El Paso County Park Advisory Board

Agenda Item Summary Form

Agenda Item Title: Bull Hill and Rolling Meadows Sketch Plan

Agenda Date: April 10, 2024

Bull Hill and Rolling Meadows

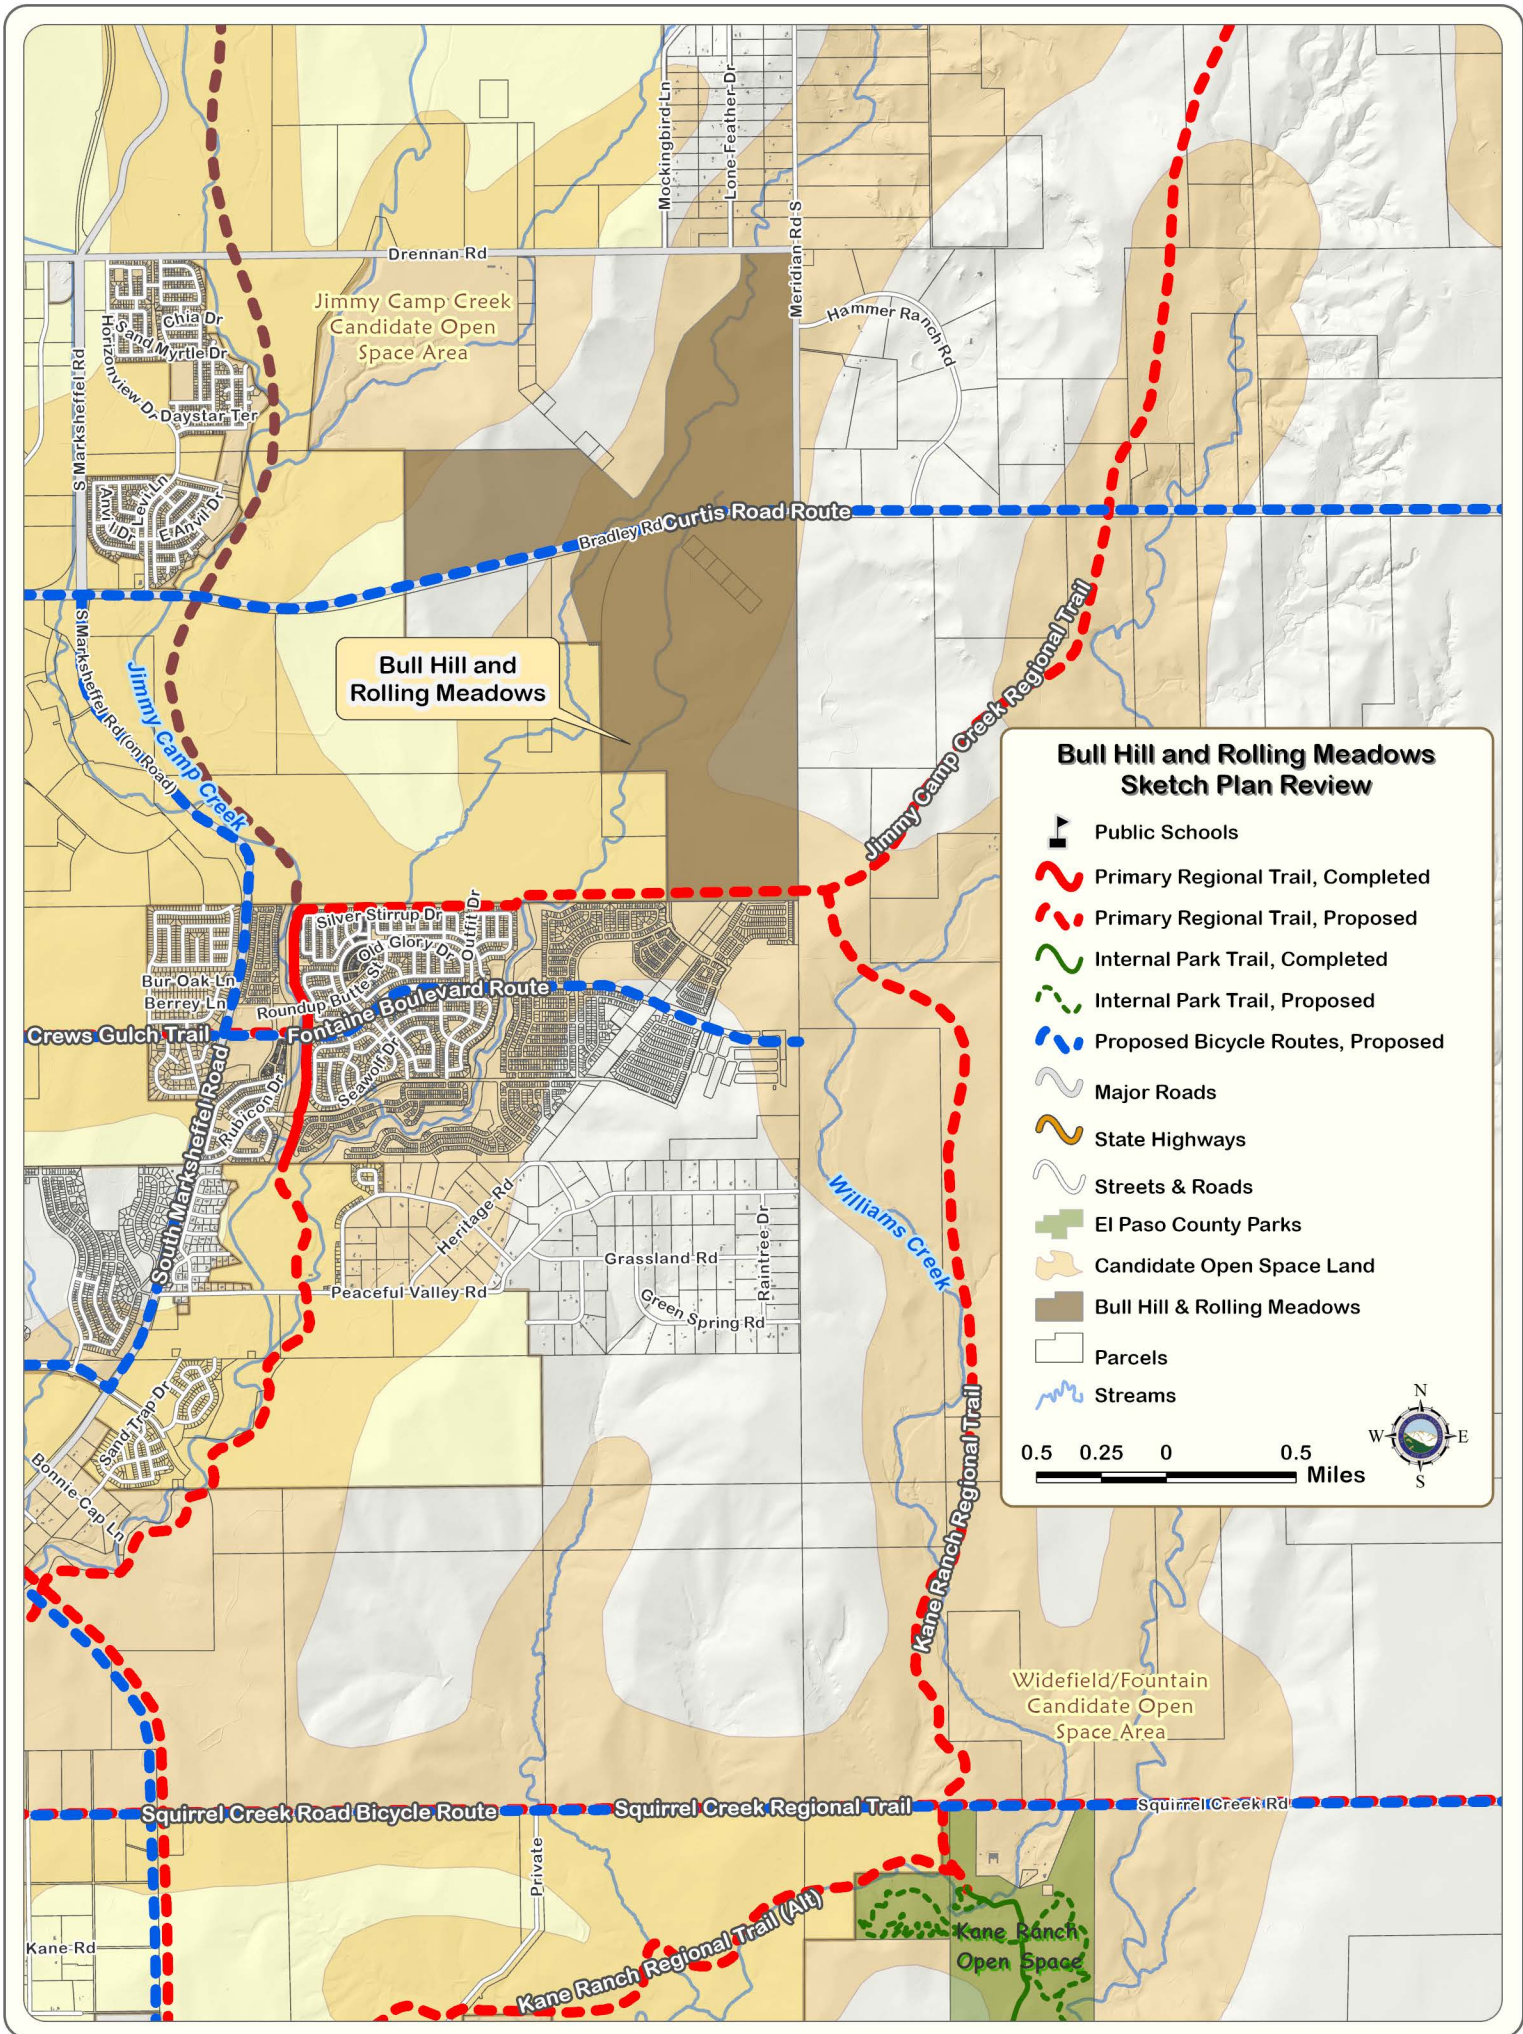
The 2022 El Paso County Parks Master Plan shows one proposed primary regional trail and one proposed bicycle route impacted by the project. The proposed Jimmy Camp Creek Primary Regional Trail is located along the southernmost property boundary, running east-west immediately adjacent to the northern boundary of the existing Lorson Ranch development. When completed, the Jimmy Camp Creek Regional Trail will connect the Town of Fountain to the City of Colorado Springs' Corral Bluffs Open Space. The northern terminus of the proposed Kane Ranch Primary Regional Trail is located immediately southeast of the project site, intersecting with the Jimmy Camp Creek Regional Trail near the project's southeasternmost corner and providing future connectivity to Kane Ranch Open Space and Clear Spring Ranch Open Space to the south.

The proposed Curtis Road Bicycle Route bisects the Sketch Plan east-west along Bradley Road. A dedicated public right-of-way already exists along Bradley Road, so no additional easement requests are necessary at that location; however, the applicant is advised that multi-modal transportation options may be developed within the right-of-way in the future.

The Candidate Open Space Area Master Plan of the Parks Master Plan shows the Jimmy Camp Creek Candidate Open Space Area encompassing a large portion of the project site, although the site is located on a minor tributary and not on the main creek channel. Natural resource values here include critical wildlife habitat, wetlands, and riparian vegetation. Water quality protection is a concern in this area that drains to Fountain Creek and where the Widefield aquifer is close to the surface. The project would not be in conflict with the plan, as long as its development does not adversely affect the surrounding existing environment. The applicant has included approximately 123.1 acres of open space areas that encompass drainage channels, floodplains, and non-jurisdictional wetland areas.

The Park Advisory Board recommends that the Planning Commission and the Board of County Commissioners include the following conditions when considering and/or approving the Bull Hill and Rolling Meadows Sketch Plan: (1) designate and provide to El Paso County a 25-foot public trail easement along the southern boundary of Bull Hill and Rolling Meadows, that allows for public access, as well as construction and maintenance by El Paso County of the Jimmy Camp Creek Primary Regional Trail; (2) the trail easement shall be shown on all forthcoming Preliminary Plans and Final Plat(s), and the aforementioned easement shall be dedicated to El Paso County on the forthcoming Final Plat(s); (3) fees in lieu of land dedication for regional and urban park purposes will be calculated upon review of forthcoming Preliminary Plans and Final Plats, and will be required at time of the recording of the forthcoming Final Plats. Park Lands Agreements may be acceptable alternatives to urban park fees provided the agreements are approved by the County and executed prior to recording the forthcoming Final Plat(s).
